ADDENDUM NO. 1

Date of Addendum: 6/27/11

PROJECT NAME: Neighborhood Street Reconstruction Project 450

PROJECT NO: WBS No. N-000382-0001-4

CITY OF HOUSTON DEPARTMENT OF PUBLIC WORKS AND ENGINEERING	APPROVED CITY ENGINEER	DATE: MAY 17, 2011	DWG NO. 01580-04
CONSTRUCTION SIGN FOR STORMWATER PROJECTS	(NOT TO SCALE)

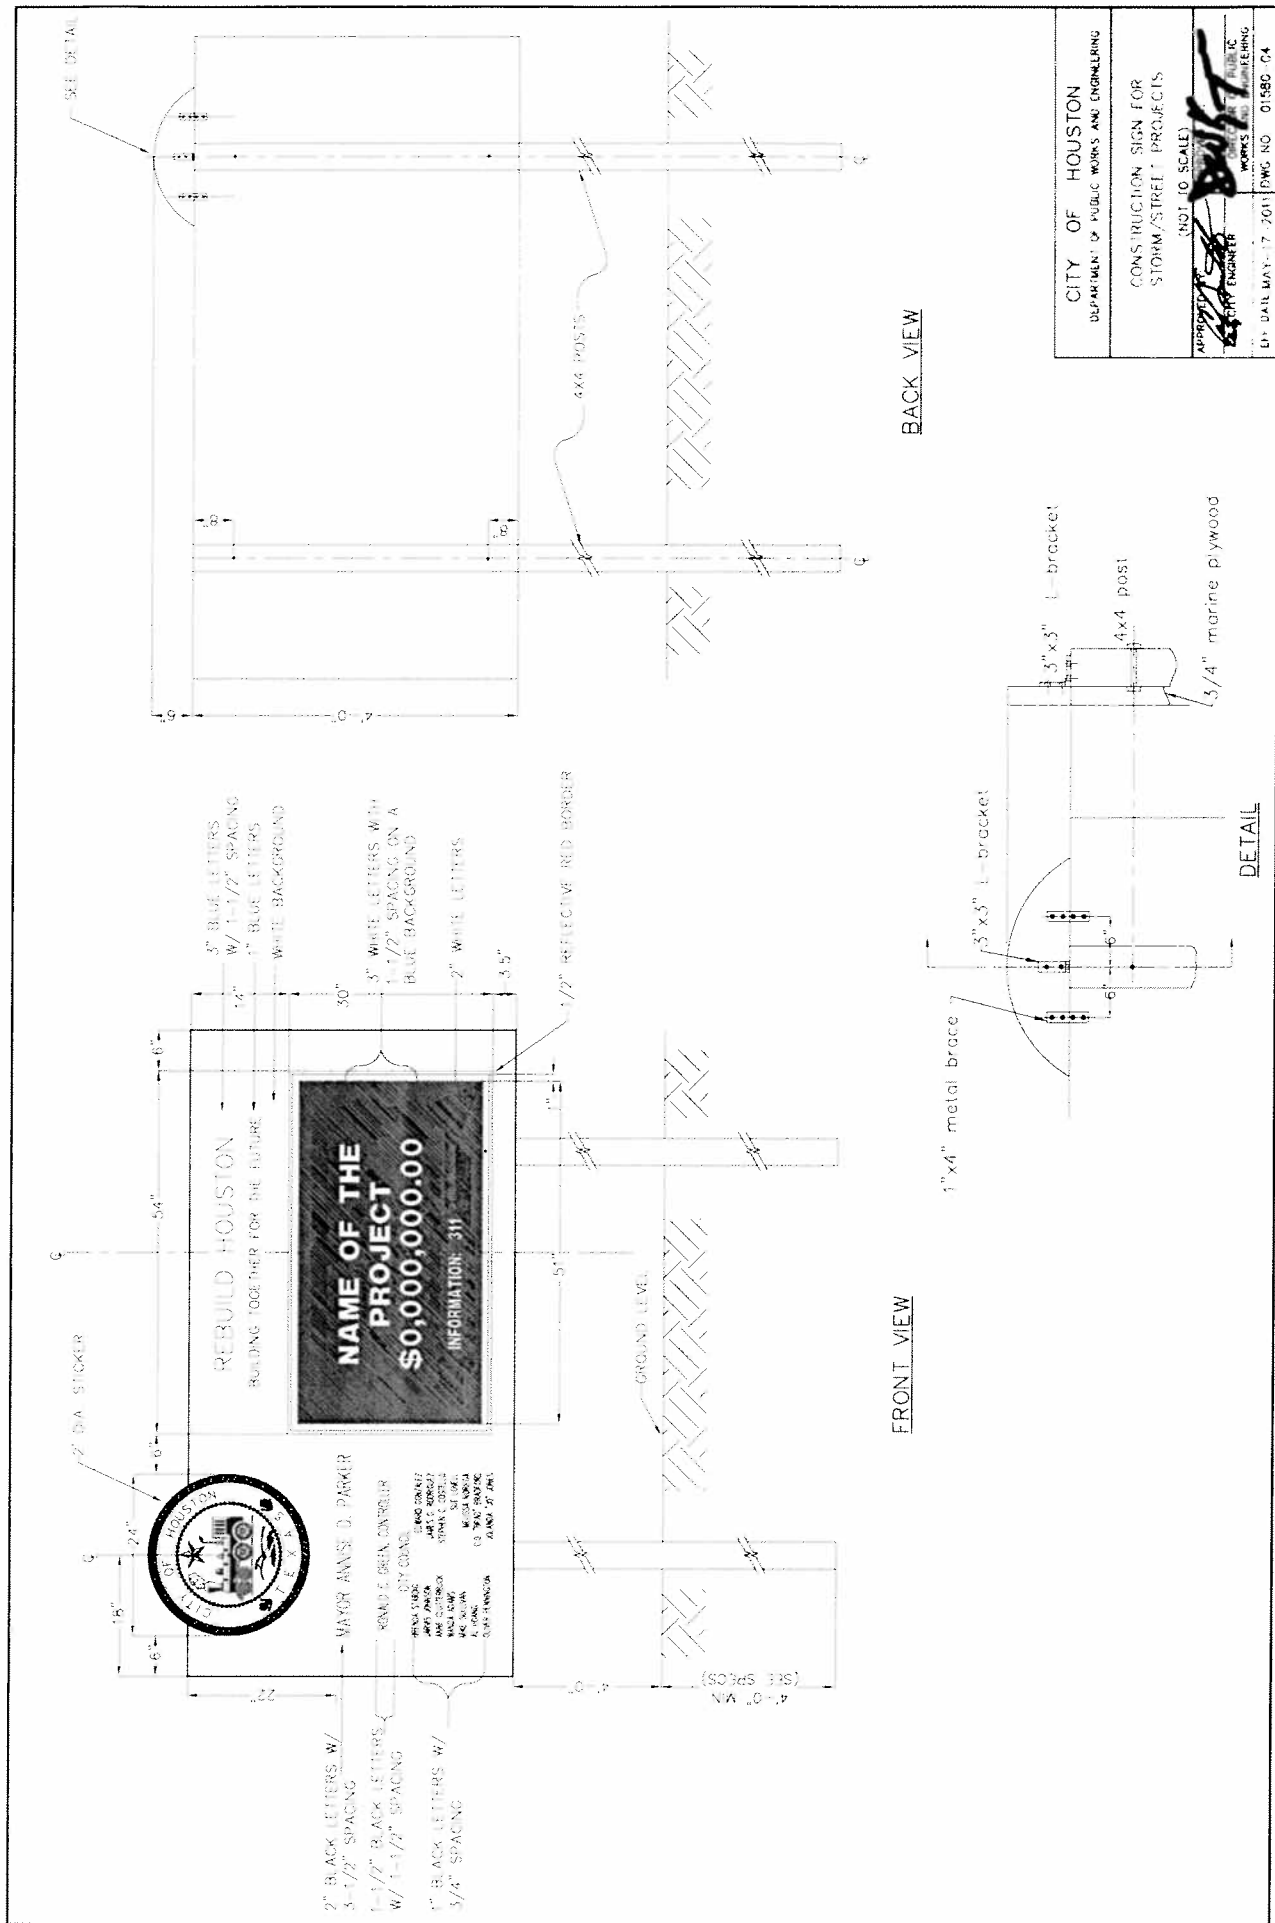
1. Sheet 65 of 114 – Delete the “Construction Sign Details” drawing and replace with the updated “Construction Sign for Storm/Street Projects” per the attached drawing.
